SITE DEVELOPMENT PLAN

HONOR CHARTER SCHOOL
HIGHMARK SCHOOL DEVELOPMENT
8250 BENT GRASS MEADOWS DR.

S-1
OF
48

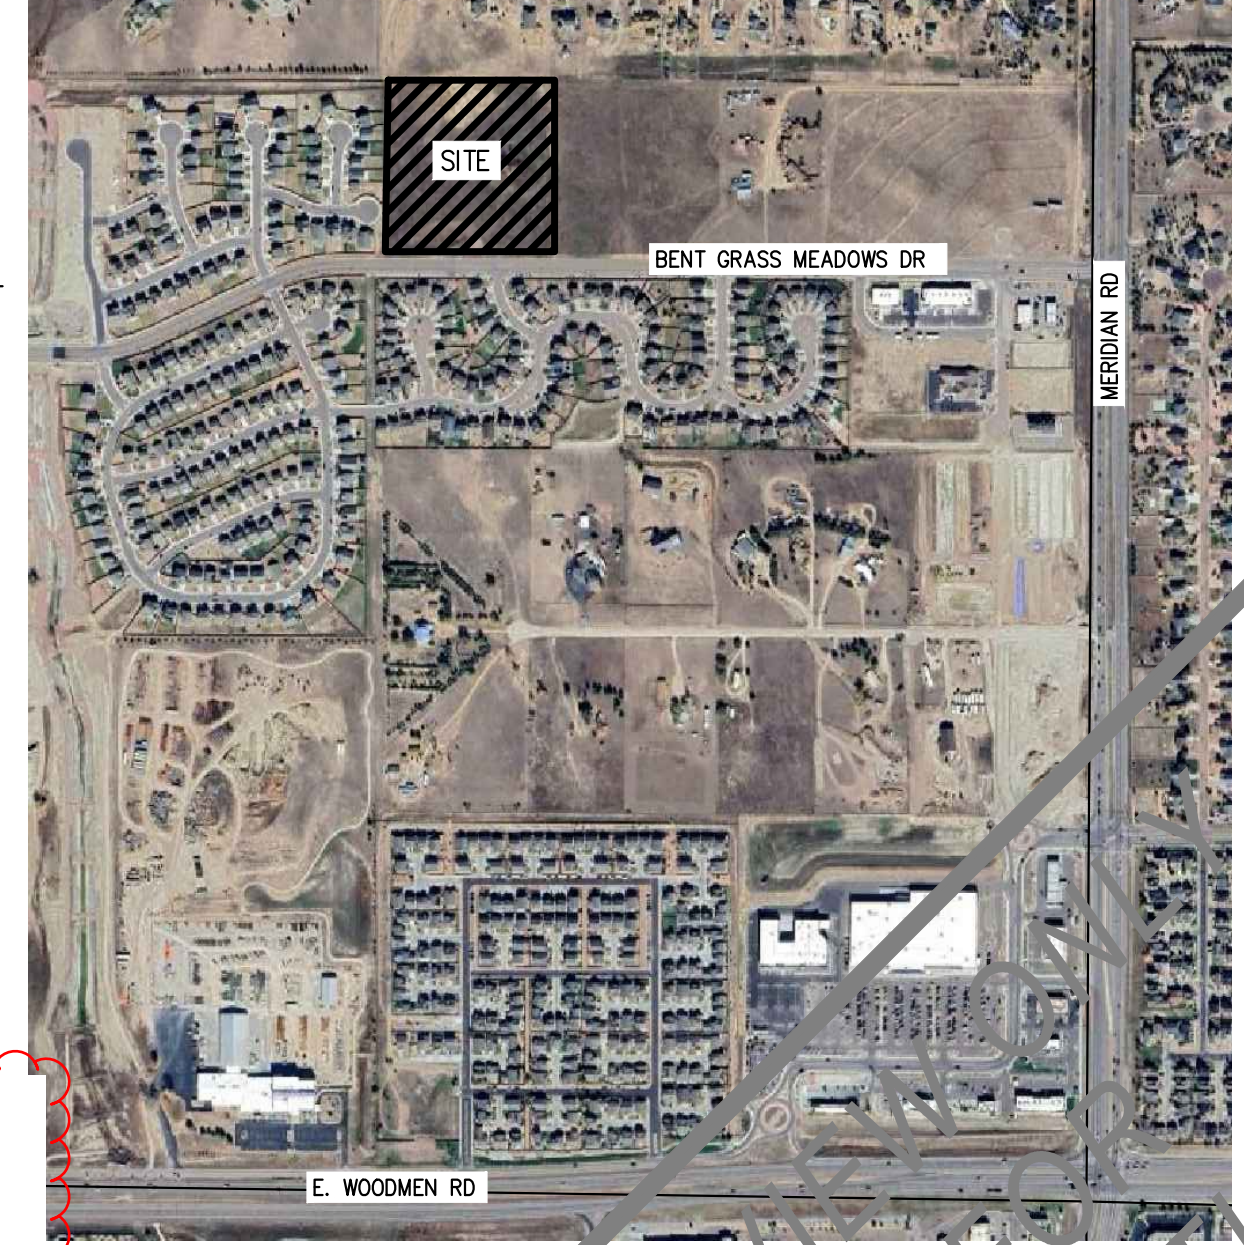
Show and label "Existing Gas Distribution Main #V20M6" to ensure no conflict with above ground structures.

Action Item: Gas meter locations on plan view and building elevations must be shown and labeled.

Action Item: Add note " Gas meters must be a minimum of 3-feet from doors, operable windows, or any vents or openings in walls."

Action Item: Add note "CSU Field Engineer to determine final gas meter, and service line locations. Contact Field Engineering at 719-668-4985 (Gas)with any questions."

RESPONSE: LABEL ADDED TO THE GAS LINE ALONG BENT GRASS MEADOWS DRIVE

RESPONSE: CHANGES MADE TO BUILDING ELEVATION PLANS PER COMMENT.
